Access Compliance Report

Public Rights-of-Way

Intersection ID: 19406	Main Street: SOUTH_BV	Cross Street: BOURBON_ST	Location: NE
ADA ID: 650A8BE0F571	Ramp Type: Directional1	Initial Pass/Fail: Fail	Overall Compliance: No
Severity Score: 12.5			
Codes/Mitigation Info/Possible Solution		Field Measurements/Component Compliance

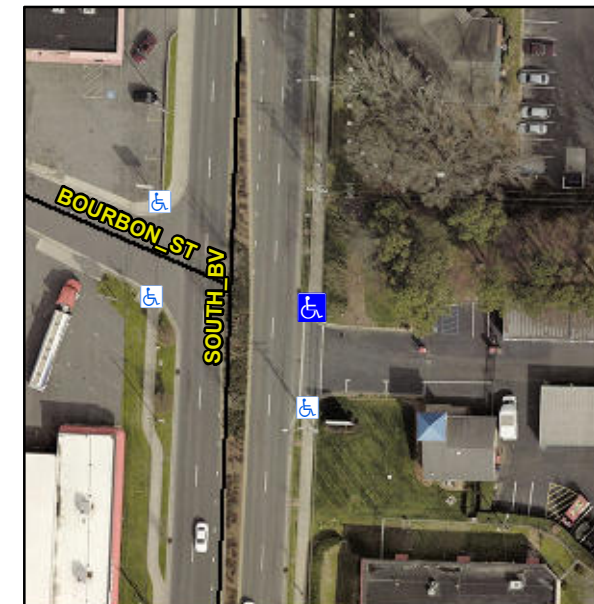
R304.5.3

Compliance	Description	Data	Compliance	Description	Data
N/A	Ramp Length (in)	123.0	N/A	Grade Break?	N/A
Yes	Ramp Width (in)	70.0	N/A	Grade Break Slope (%)	0.0
Yes	Ramp Slope (%)	5.2	N/A	Grade Break XSlope (%)	0.0
No	Ramp XSlope (%)	6.7			
N/A	Flare Type LT	N/A	N/A	Flare Type RT	N/A
N/A	Flare Slope LT (%)	N/A	N/A	Flare Slope RT (%)	0.0
N/A	Flare Traversable LT?	N/A	N/A	Flare Traversable RT?	N/A
N/A	Landing Length (in)	0.0	N/A	DWS Provided?	N/A
N/A	Landing Width (in)	0.0	N/A	DWS Contrast?	N/A
N/A	Landing Slope (%)	0.0	N/A	DWS Length (in)	N/A
N/A	Landing X Slope (%)	0.0	N/A	DWS Full Width?	N/A
N/A	Landing Curb? (Y/N)	N/A	N/A	DWS Offset LT (in)	N/A
N/A	Shared Landing?	N/A	N/A	DWS Offset RT (in)	N/A
N/A	Gutter Ponding?	0.0	N/A	Gutter Slope (%)	N/A
N/A	Gutter Lip Ht (in)	0.0	N/A	Gutter X Slope (%)	N/A
N/A	Painted X Walk1?	Yes		Road Slope (%)	0.3
	X Walk 1 Direction	To S		Road X Slope (%)	7.0
	X Walk 1 Width (in)	110.0		Clear Space?	N/A

Remove & Replace Entire Ramp.
